DOCUMENT CHANGE REQUEST

DCR number 373	Changes required for: General	Originator: S Jeffery
Date: 2007/08/10	Date sent: 2007/08/10	Organisation: ESA/ESTEC
Status: IMPLEMENTED

Title:	Transistors High Power NPN, based on types 2N5664 through 2N5667		
Number:	5203/038	Issue:	1

ESCC Detail Specification No. 5203/038

3. Safe Operating Area applies as follows:

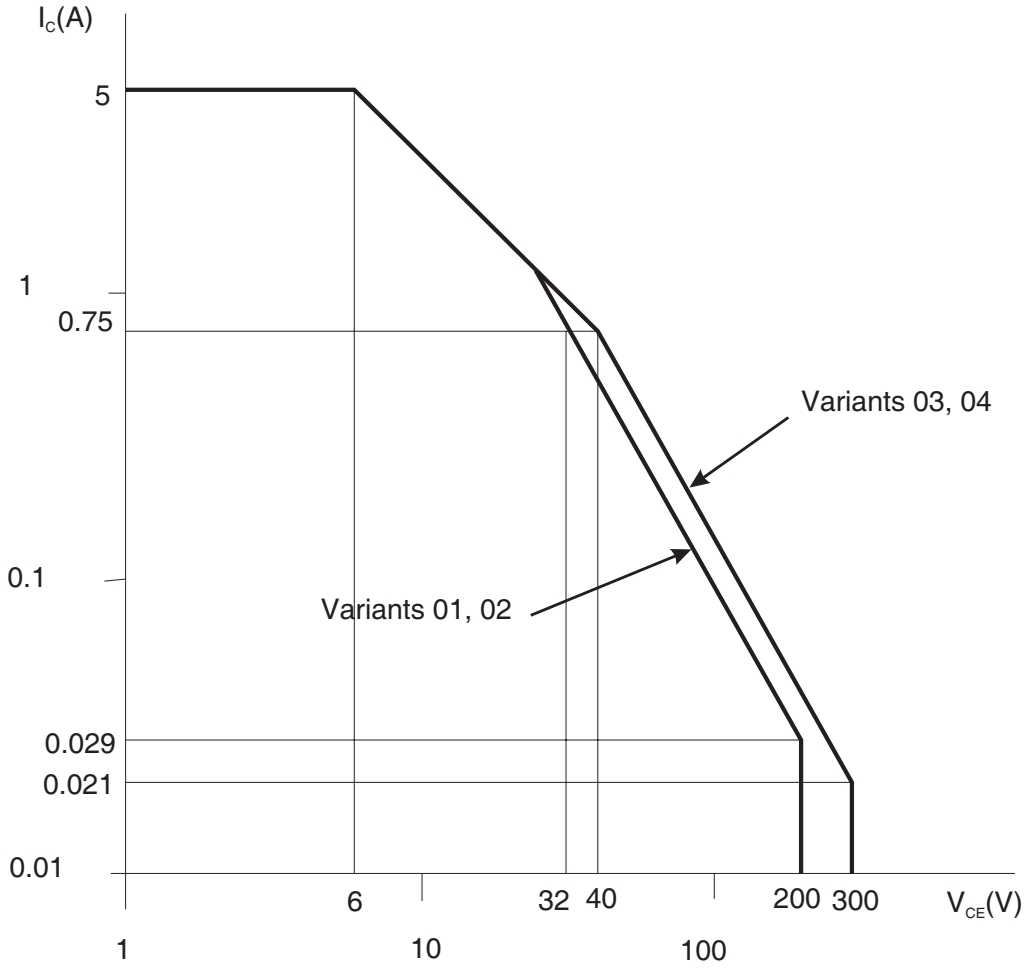
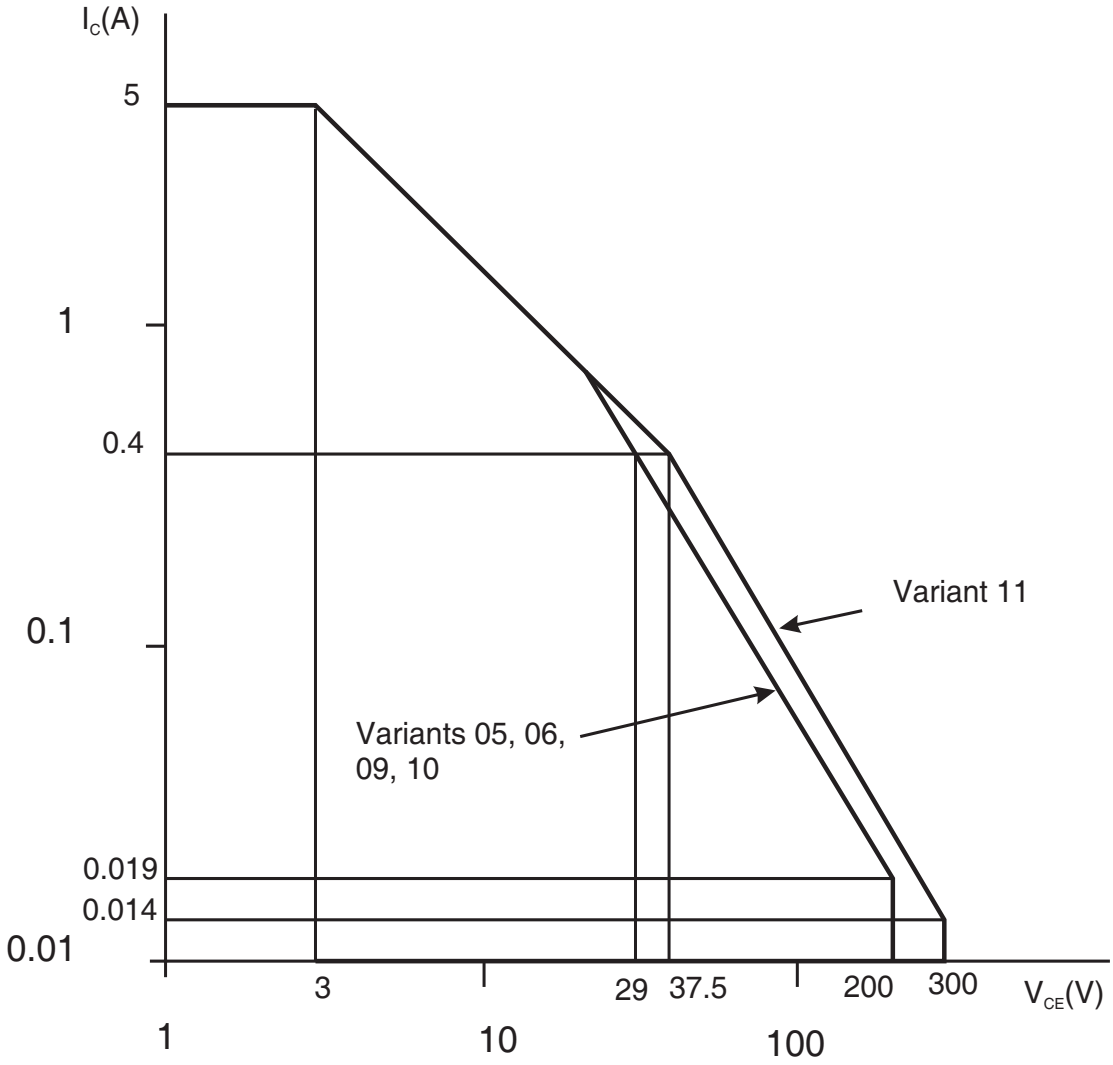
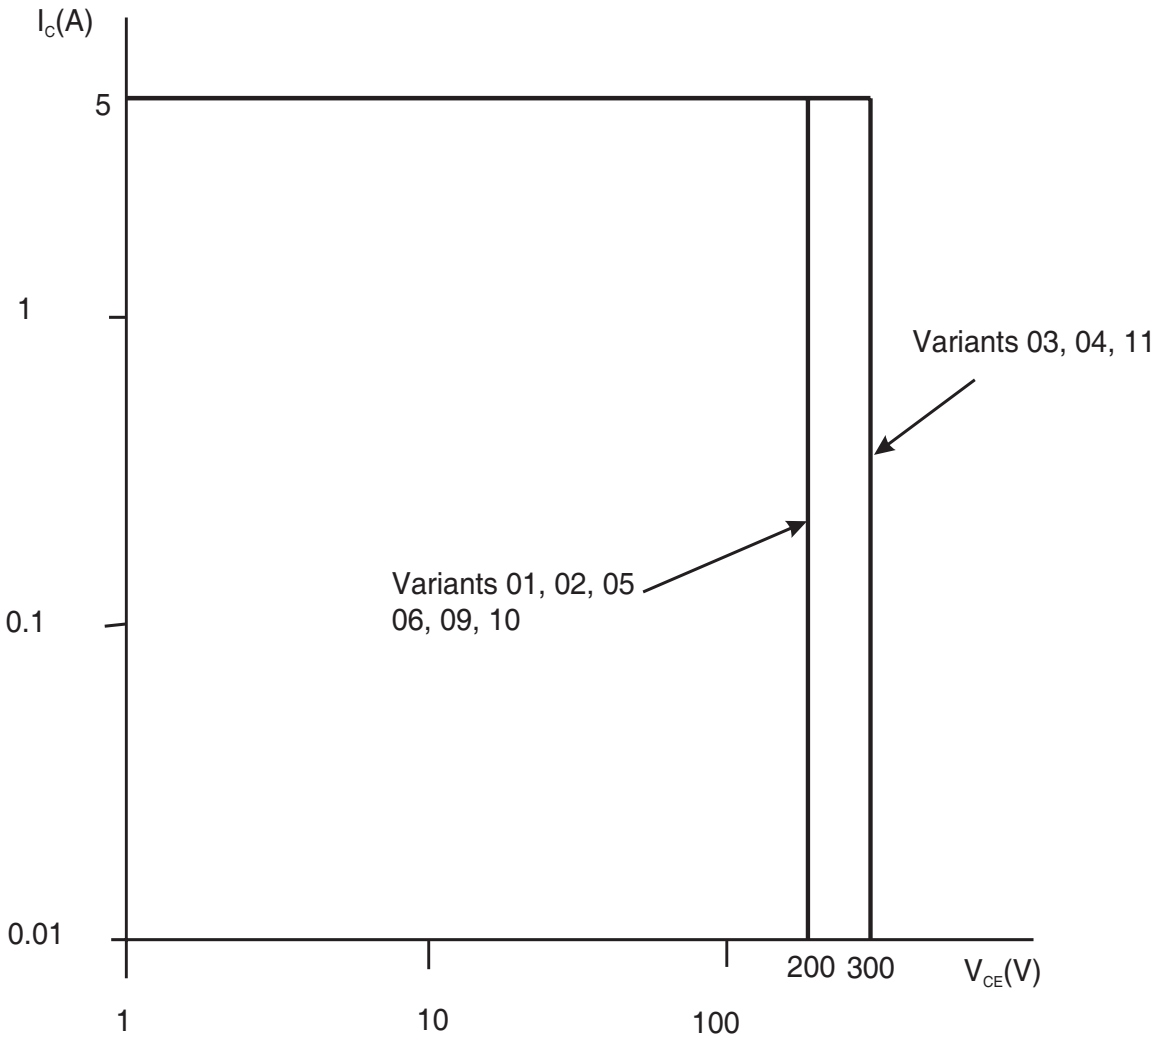
8. Figures 1(b) and 1(c), Forward Bias Safe Operating Area, amended and moved to be a note (Note 3) to the Maximum Ratings table.

1.6 PHYSICAL DIMENSIONS AND TERMINAL IDENTIFICATION

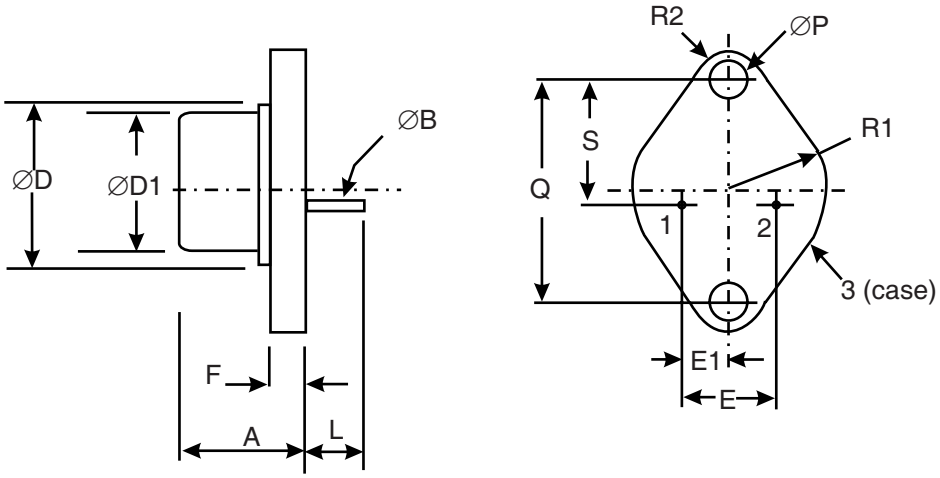
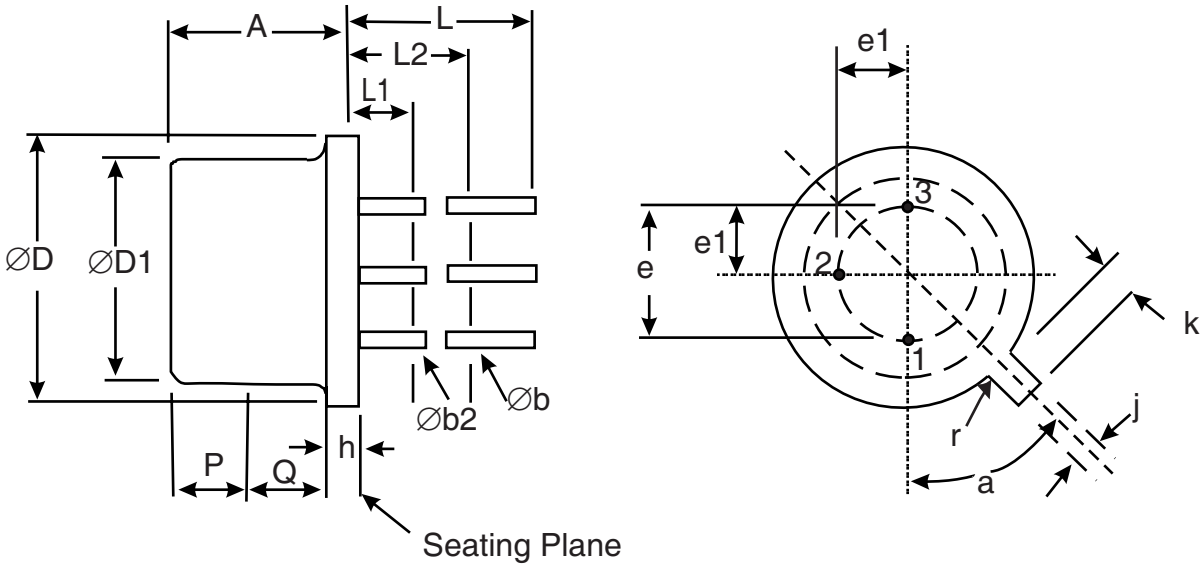
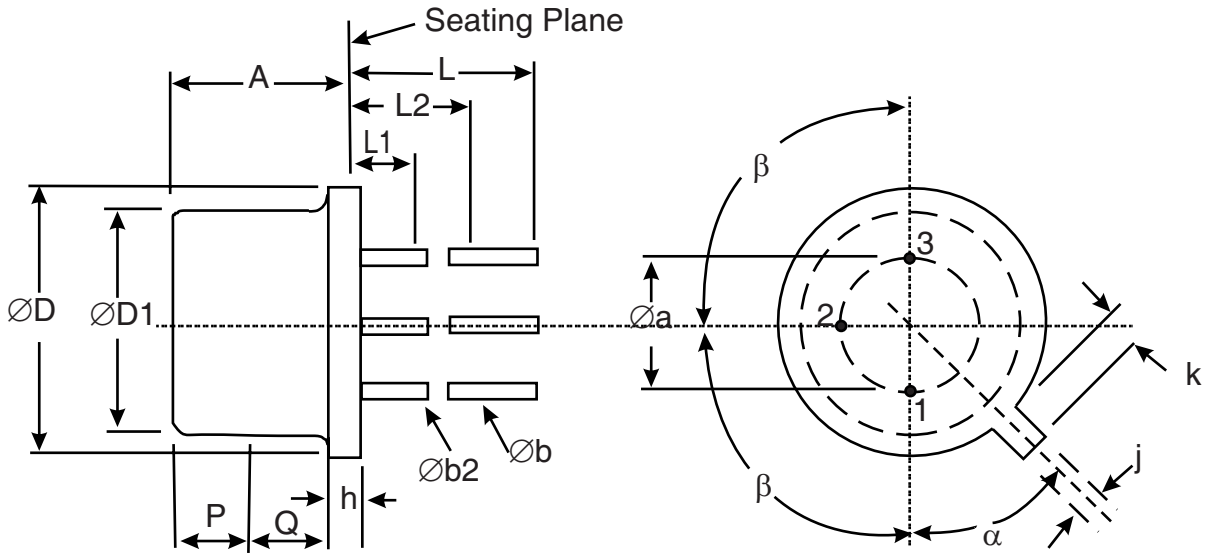
10. Figure 2 re-named "Physical Dimensions and Terminal Identification"; Figures 2(a), 2(b) and 2(c) amended (standardisation of the TO-66, TO-5 and TO-39 packages) and Consolidated Notes added.

VOLTAGE WAVEFORMS

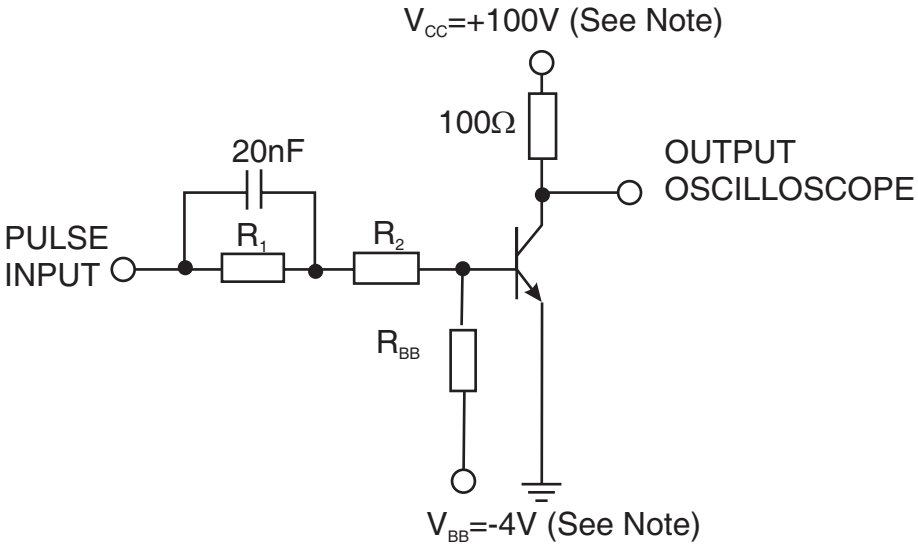
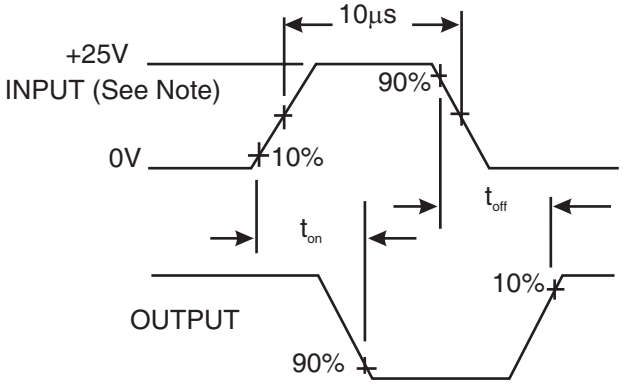
28. Figures 4(a) and 4(b) amended and combined (and Voltage Waveforms added) and moved to be a note (Note 4) to Room Temperature Electrical Measurements.
